QUESTION 2H.1 (DRL 2.7) Discuss the water flow patterns in the vicinity of the plant and their associated consequences on plant operations following a failure of the on-site water storage facilities.

QUESTION  
2H.2  
(DRL 2.8)

Docket 50-312  
Amendment No. 2  
April 15, 1968  
Appendix A to Question 2H.2

FIGURE 2H.2-2  
NON-INSTRUMENTED SEISMIC EVENTS  
V INTENSIVE (M.M.) AND ABOVE

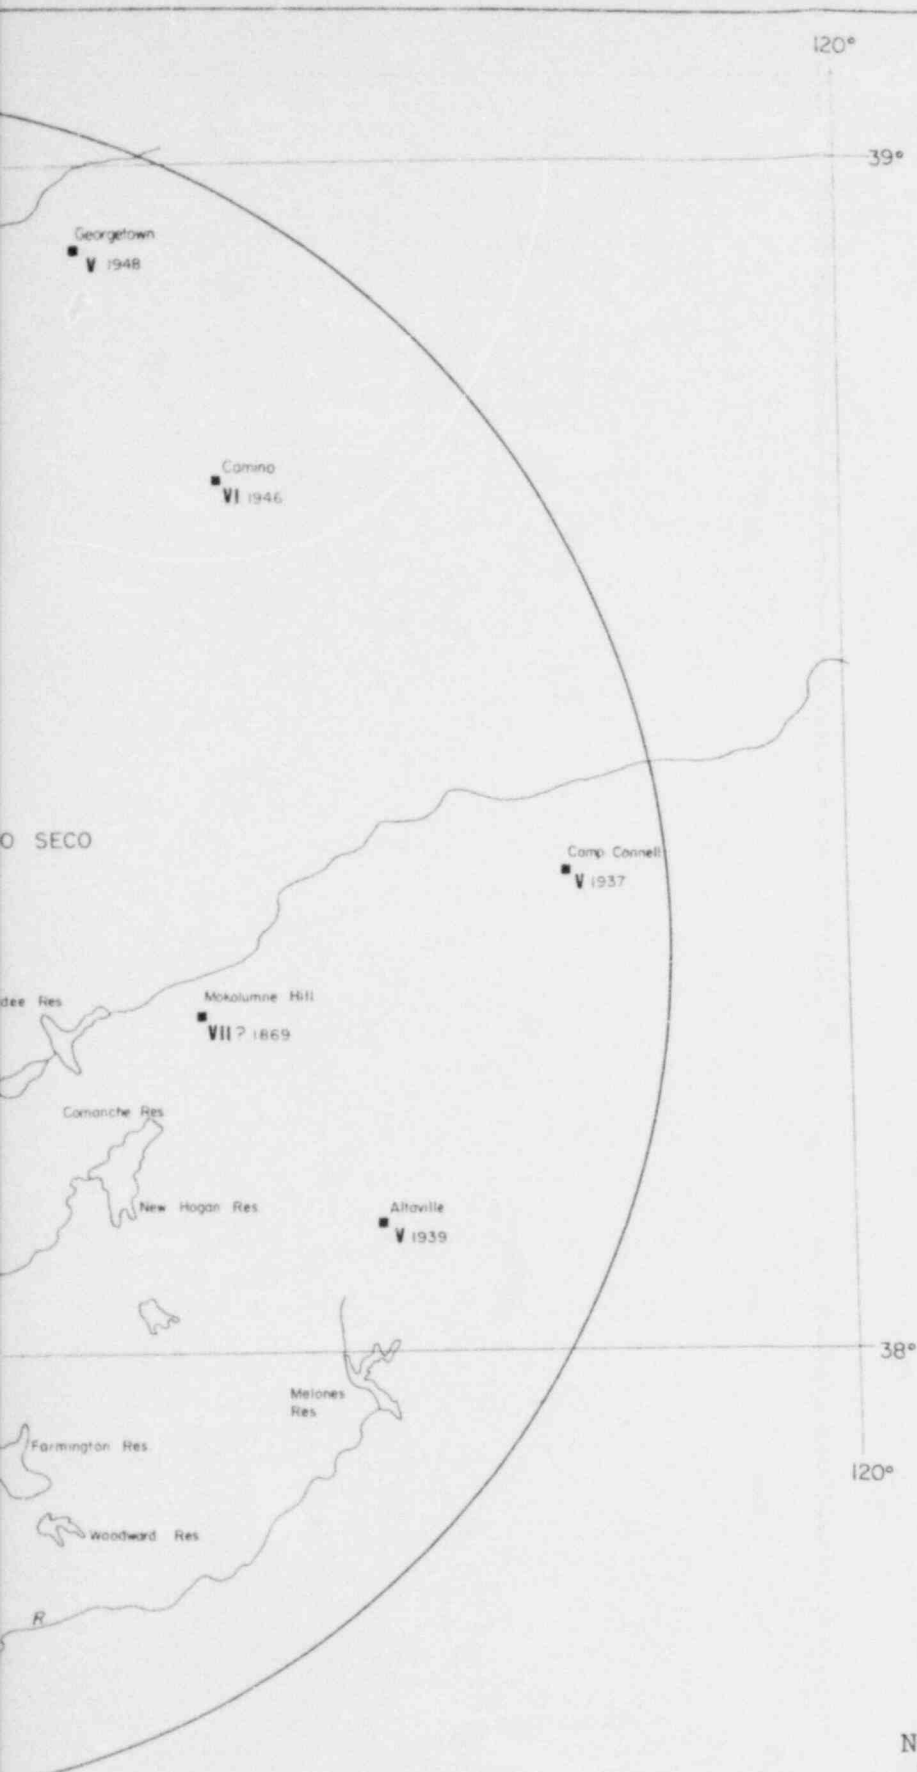
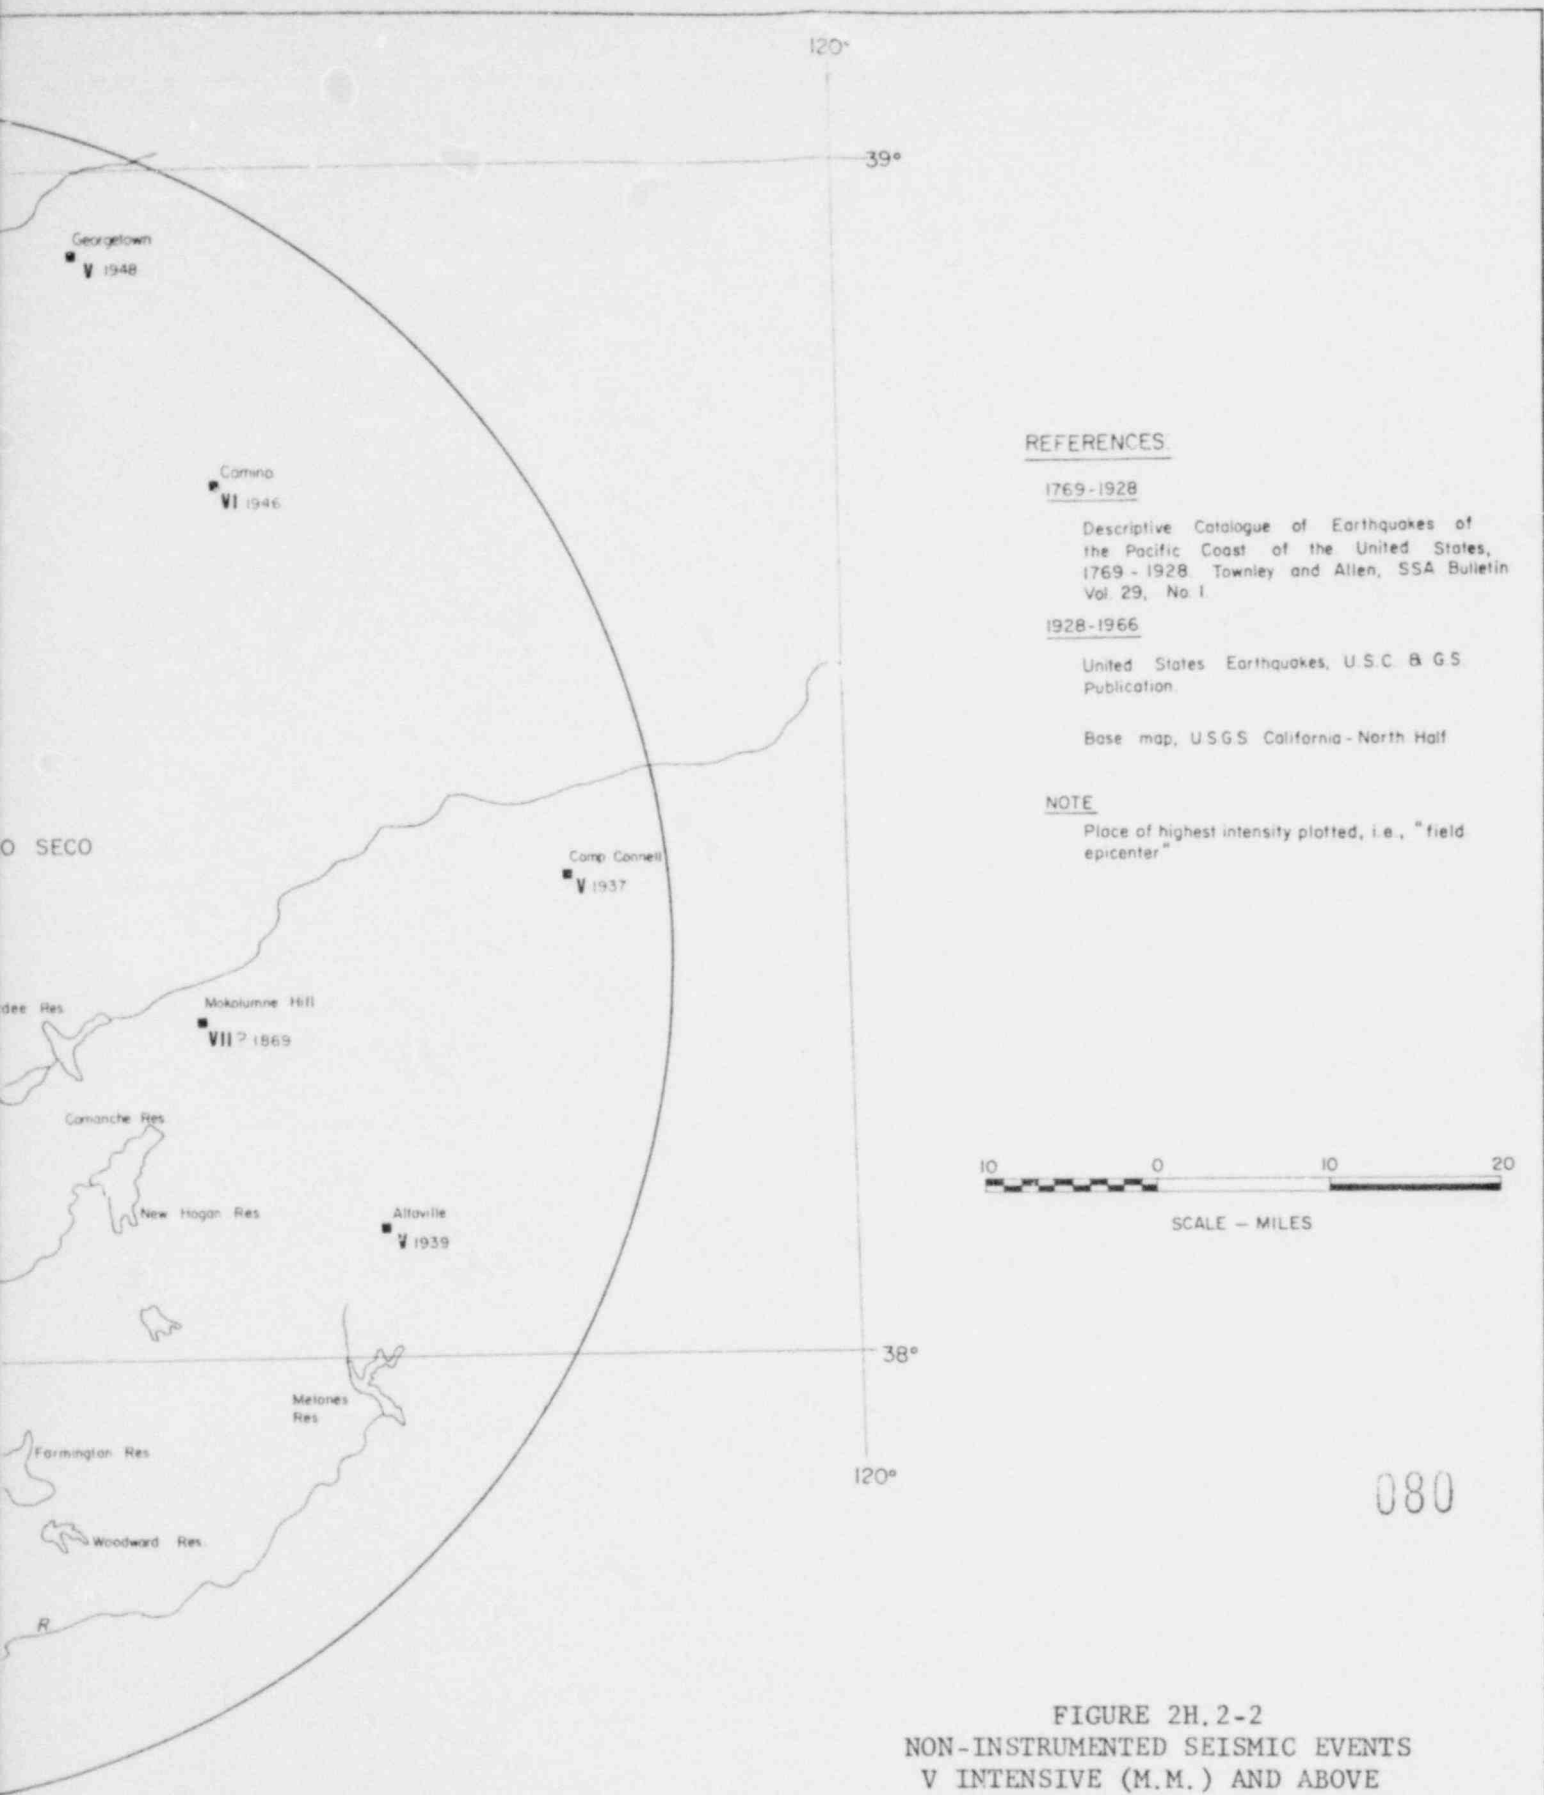
Provide a map of earthquake epicenters within a radius of 200 miles showing all earthquakes of intensity V or greater at the epicenter.

The instrumented epicenters and non-instrumented seismic events within a 50 mile radius of the Rancho Seco site are shown on Figures 2H.2-1 and 2 respectively.

The epicenter map shows the magnitude of earthquakes actually recorded, while the non-instrumented seismic event map shows the highest intensity reported for any earthquake. It is considered that the 50 mile radius map presents a meaningful description of the site and adjacent area since varying geological conditions need not be evaluated. Similar maps for a 200 mile radius are shown in Figures 2H.2-3 and 4.
